KENWOOD

ASB-995

SERVICE BULLETIN

TS-450/TS-690 Calibration Cable Change

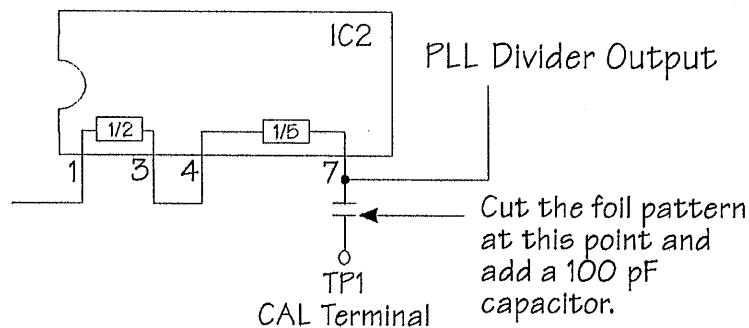
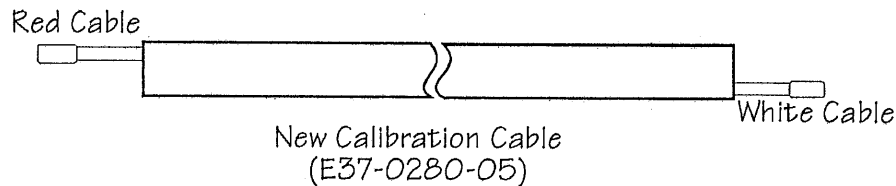
The TS-450/690 may not calibrate properly against WWV (JJY) when using the calibration cable that is supplied with early versions of these sets, (Serial numbers below 311XXXX) and when an antenna that is shorted for DC is used. A dipole with a balun is a prime example of a DC shorted antenna. This failure is antenna specific; i.e. multiband beams and other similar antennas do not cause this failure.

A new calibration cable is available that provides proper DC isolation. Failure to use the new style cable will result in a PLL unlock condition when calibration is attempted. A temporary countermeasure that can be used until the new cable is obtained is to use a two conductor shielded wire. A minor circuit modification that adds a 100 pF isolation capacitor should also be performed. Please refer to the diagrams below for modification notes.

E37-0280-05	Calibration Cable Assembly	1 Ea.
CK73FCH1H101J	100 pF Capacitor	1 Ea.
